Groundwater Modeling and UMTRA

Groundwater Modeling - Gunnison

Potentiometric Surface Map

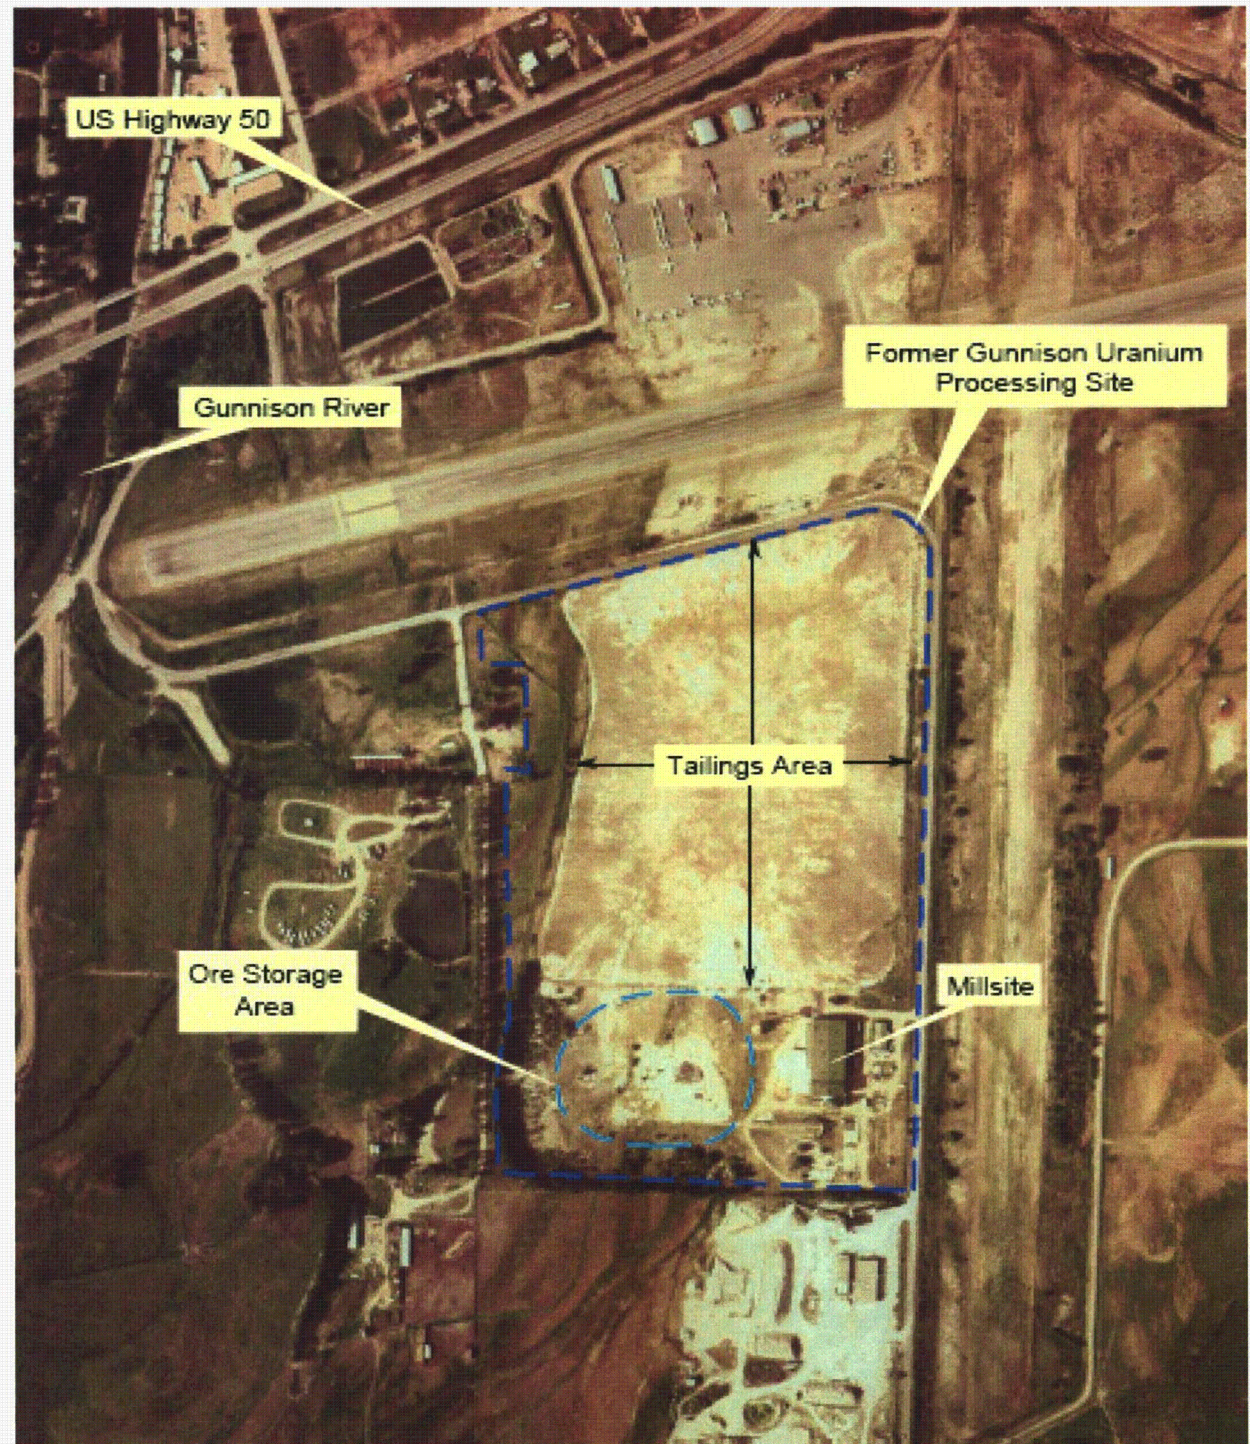
I have attached the power point slides that Rich spoke from way back when, and the areas of interest to Paul are to the south, near the Tomichi creek. If you look at slide 5 you can see a lack of monitoring wells to the south but slide 6 which was used in the modeling shows a number of wells in that area. Also, if you look at slides 12-14 you will see the 'hot spot' referred to by Paul, so his concern is that it was derived without many wells, but they are shown in slide 6.
